Higa Seawall at Ewa Beach

CHAPTER 343, HRS
Environmental Assessment/Determination
Negative Declaration

**COASTAL ENGINEERING EVALUATION
AND ENVIRONMENTAL ASSESSMENT
FOR A SEAWALL AT
EWA BEACH, OAHU, HAWAII
(TMK: 9-1-07:72)**

Subject: Draft Environmental Assessment for Higa After-the-Fact
Seawall

Owner: James H. Higa
Address: 91-049 Parish Dr.
Purpose: Wall Constr FIGURE 4

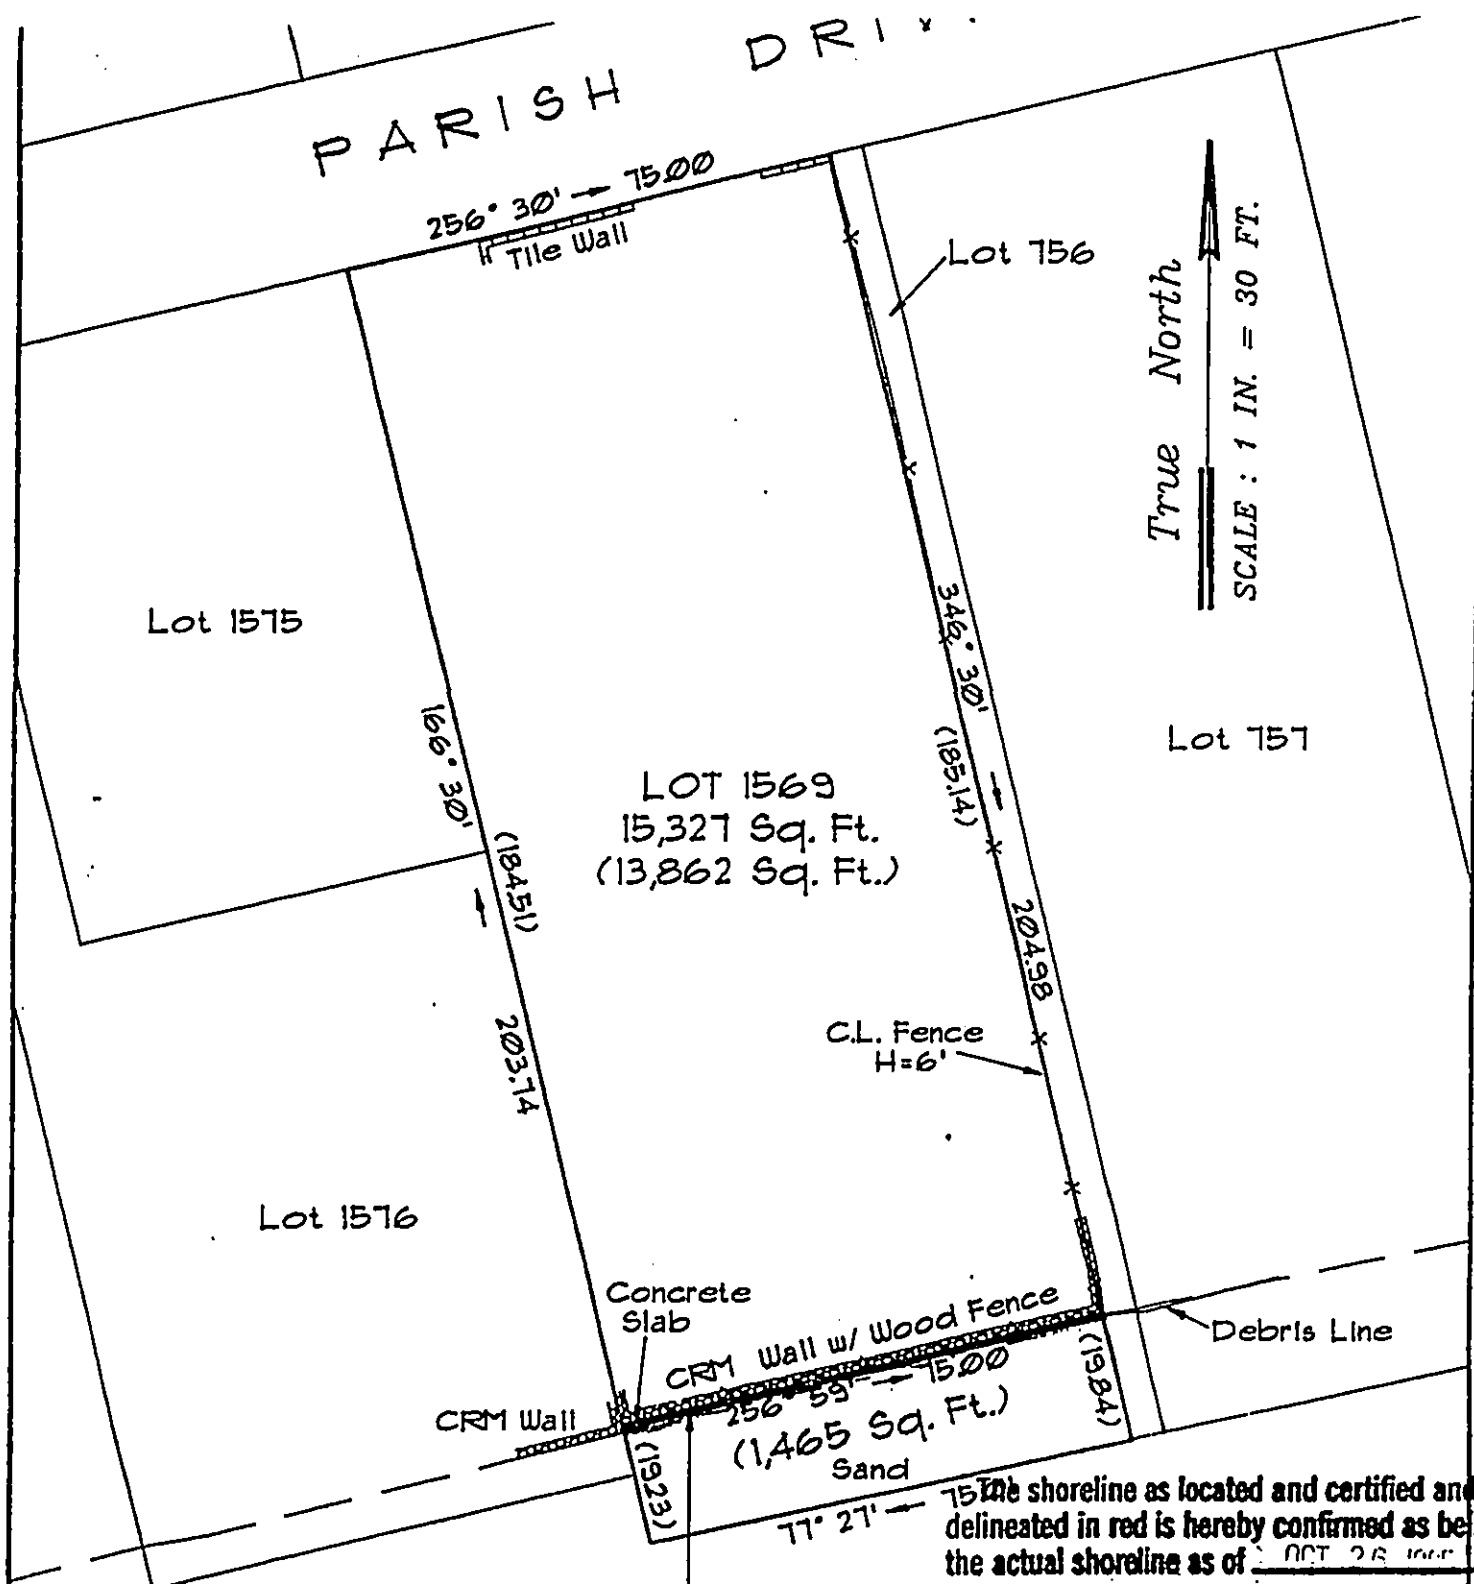
5. An analysis of any existing nearby walls or revetments and their cumulative impacts on the shoreline.
6. A description of structures and improvements (such as homes or swimming pools) on the subject property, their distance from the property line and shoreline, and how they may be affected by the construction of the proposed hardening project.

6. Photographs and the Figure 4 survey map show the location of improvements on the subject property relative to the property line and shoreline.
7. Refer to item 1.

FIGURE 5

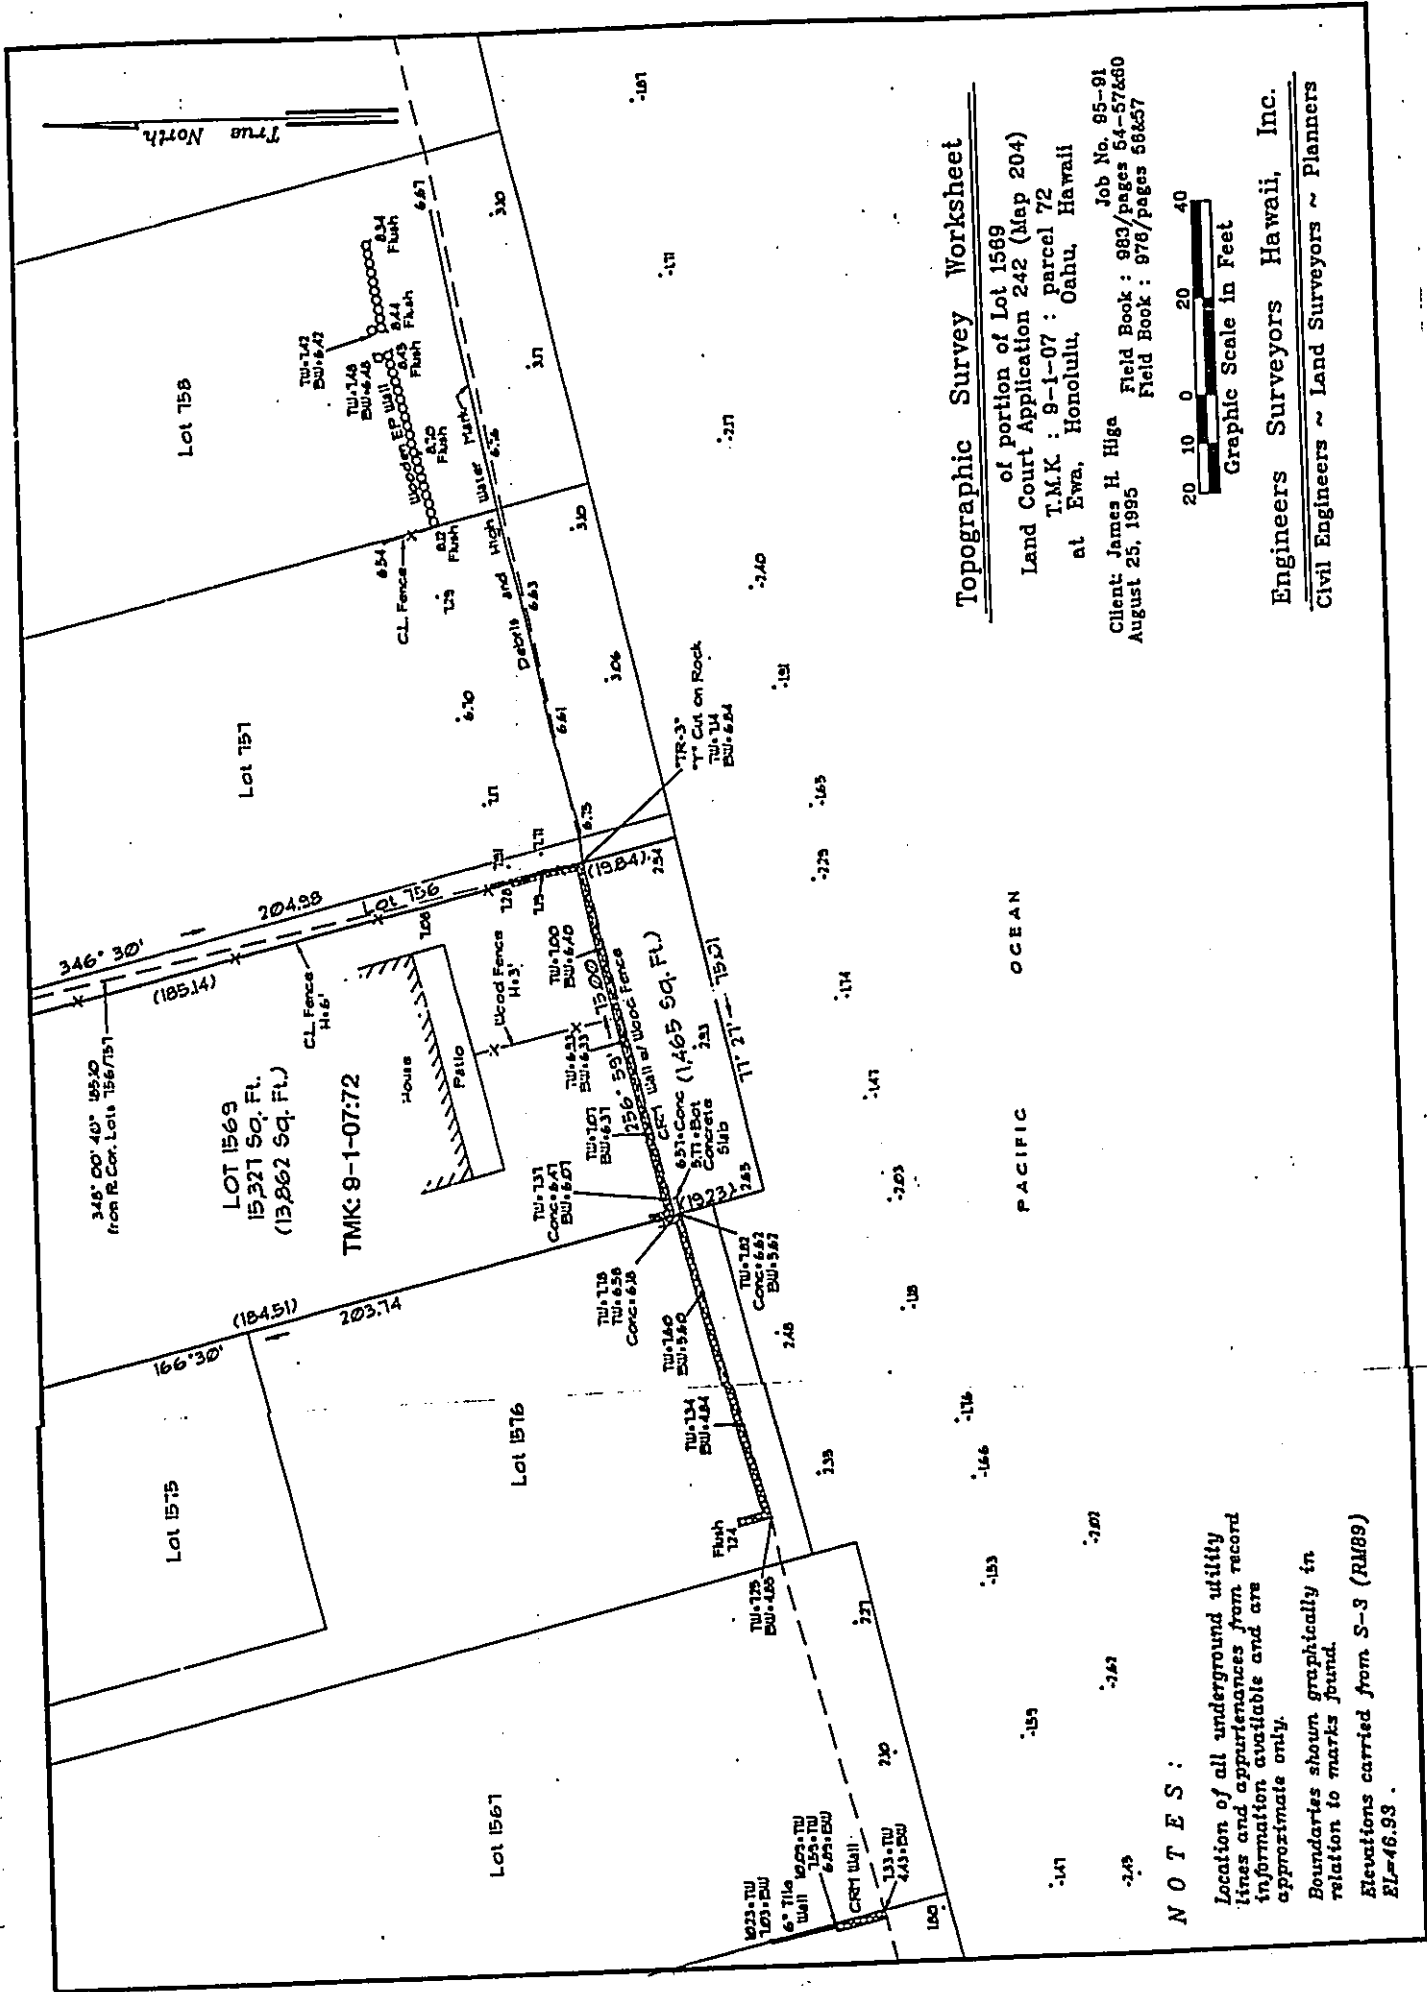
11. There is no indication that the shoreline has been recently certified by the Department of Land and Natural Resources. What is the status of the shoreline certification for this shoreline variance application?
12. Please provide reasons for supporting the determination based on an analysis of the significance criteria in section 11-200-12 of the Hawaii Environmental Impact Statement Rules. Refer to section D of the enclosed sample as a guideline.
13. Please list the names of all agencies consulted during the review process.
14. Please identify the approving agency in the environmental assessment.

2. A copy of the certified shoreline survey should be included in the Final EA.

11. The shoreline was recently certified by DLNR as following the face of the existing seawall as depicted in Figure 7.
12. The final EA will address the significance criteria in Section 11-200-12 of the Environmental Impact Statement Rules to support the determination of no significant effect.

Photo 1. Condition of beach and seawall in July 1995.

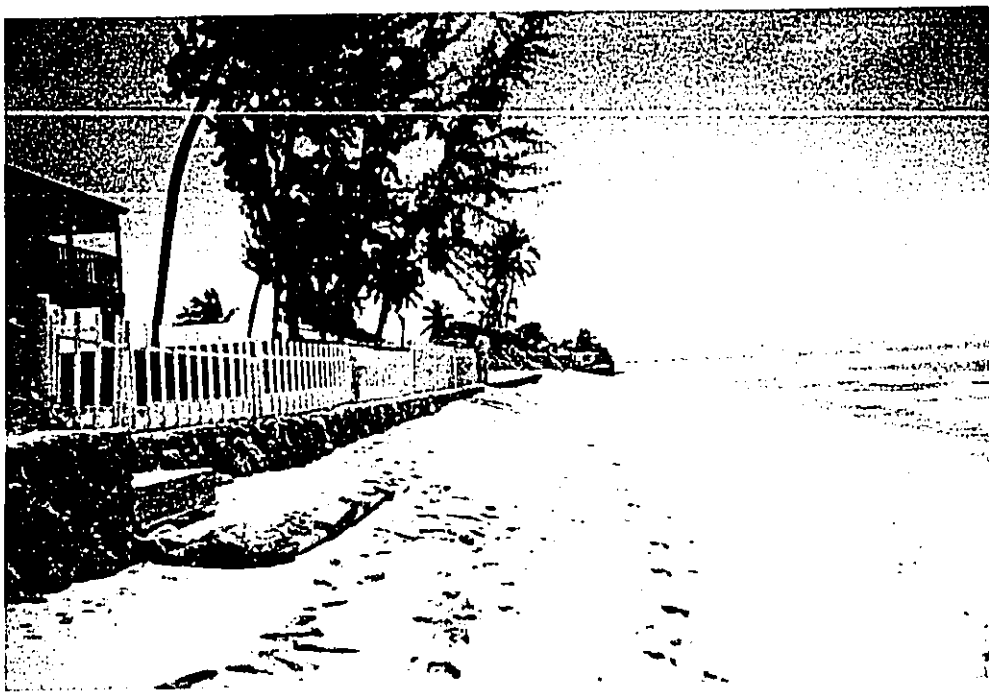
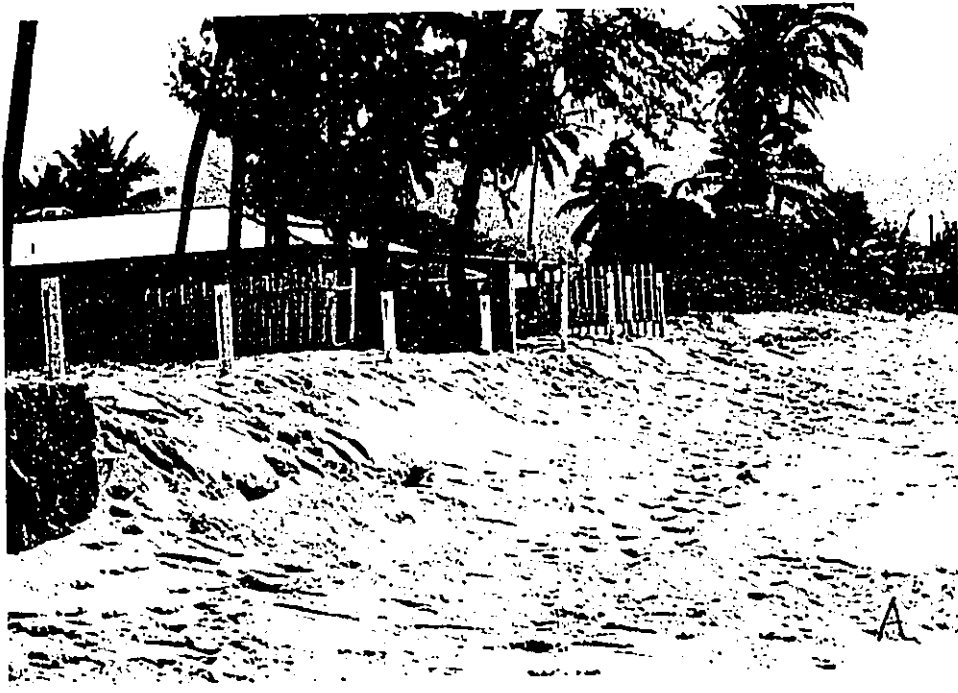
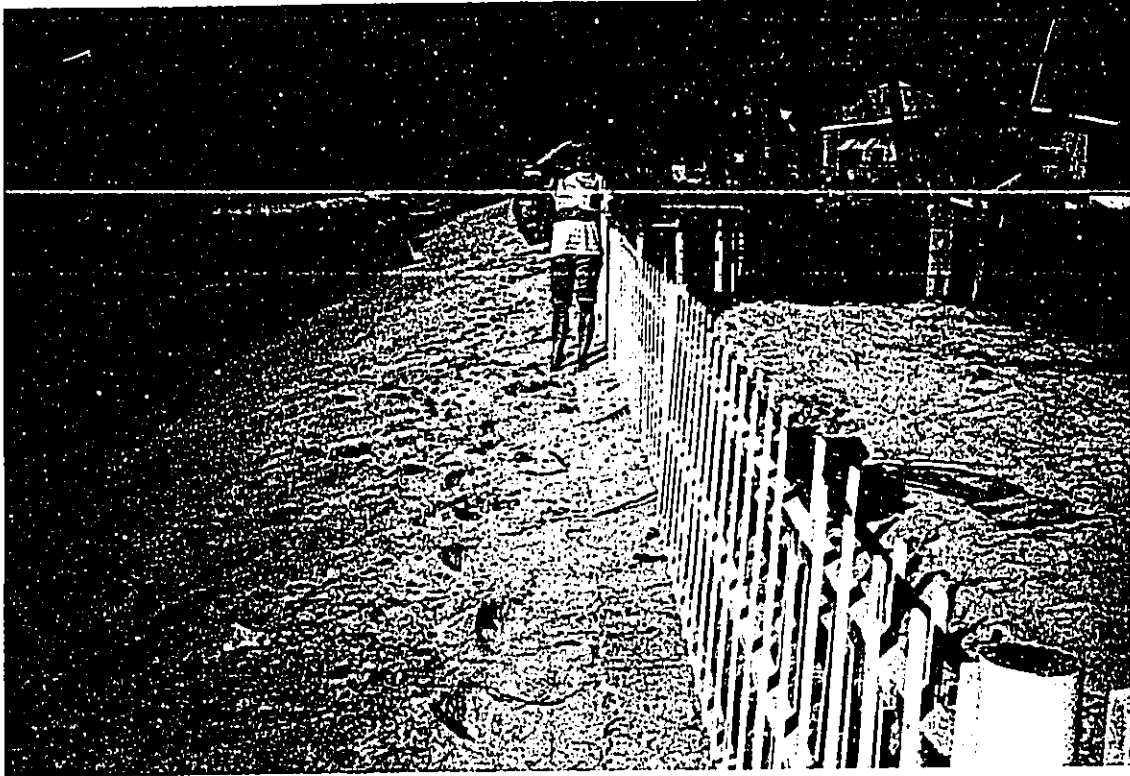
9. Photos of the site that illustrate past and present conditions and locate the proposed structure.
10. All alternatives to shoreline hardening should be thoroughly researched and analyzed. These alternatives should include beach replenishment, dune-scaping, retreat from the shoreline by moving existing structures inland, a no action alternative, and removal of the existing seawall.

9. The EA contains photos showing past and present conditions of the subject seawall.
10. The range of alternatives discussed in the EA is commensurate with the relative scope (size) of the assessed project and the viability of reasonable alternatives. Beach replenishment is not considered a "viable" alternative for individual residential property owners. Beach nourishment is not considered practicable for individual homeowners until and unless a vehicle is in place providing for long-term legal and financial commitment to provide periodic nourishment, of sufficient quantity to prevent future erosion damage, along a shoreline reach encompassing multiple residential parcels. For individual residential parcels such as the Higas' 75-foot shoreline frontage, beach nourishment is technically not a viable option unless shore-perpendicular structures (such as groins) are built to contain the beach fill fronting the property. Beach nourishment is a viable erosion control option only if it can be implemented along a reasonable long stretch of coastline or within a defined littoral cell. Because of the legal, regulatory, and financial requirements, beach nourishment is presently a potentially feasible option only for public agencies or property owners, such as resorts, who can justify the expense of providing and maintaining high value recreational beaches.

A TYPICAL SECTION OF EXISTING SEAWALL

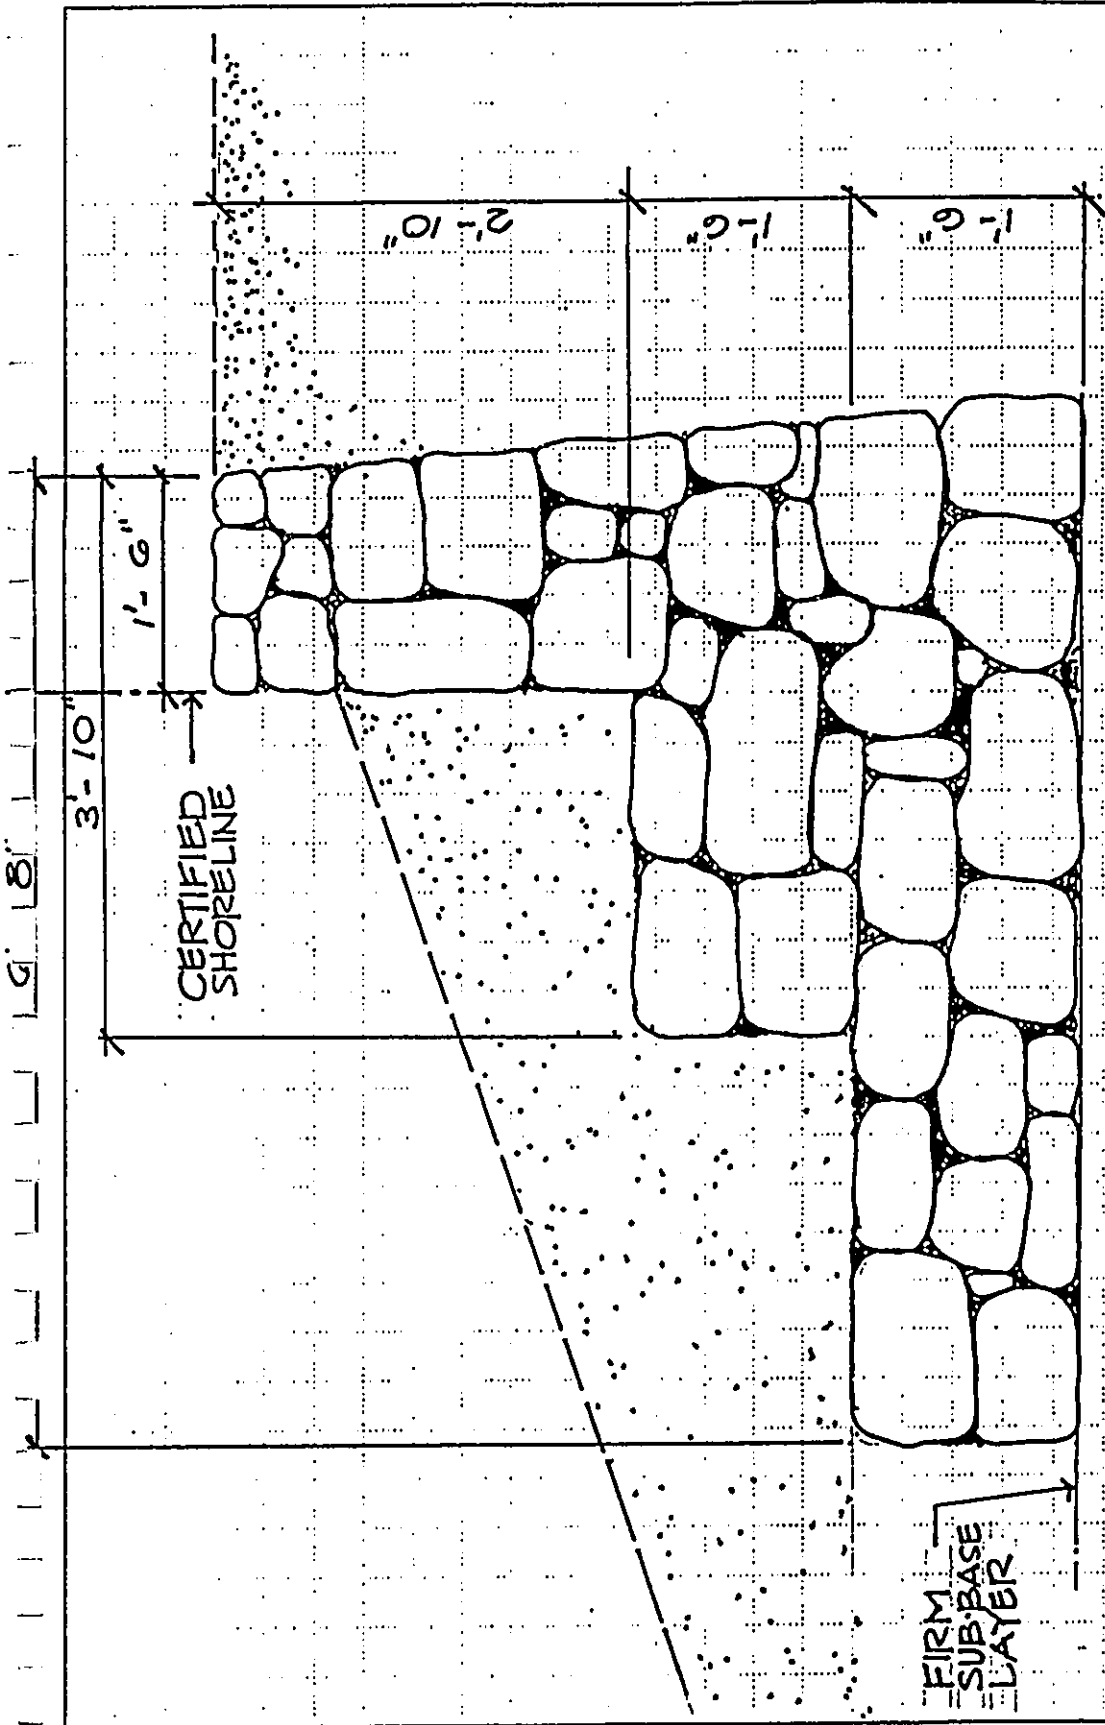
3. A copy of the engineer-stamped cross-sectional plan of the seawall should also be included in the Final EA. The location of the certified shoreline and "As Built" should be noted on the cross-sectional plan. The Draft EA mentions that the seawall was constructed on a coral limestone platform. This limestone platform should be noted on the cross-sectional plan.

1. We have made inquiry with DLNR as to whether DLNR will require a formal application for a conservation district use permit in light of the fact that Department of Land Utilization ("DLU") is already reviewing the present application. We shall keep DLU apprised of DLNR's determination.
2. A copy of the certified shoreline survey will be included in the final EA.
3. An engineer stamped cross-sectional plan of the seawall will be included in the final EA.
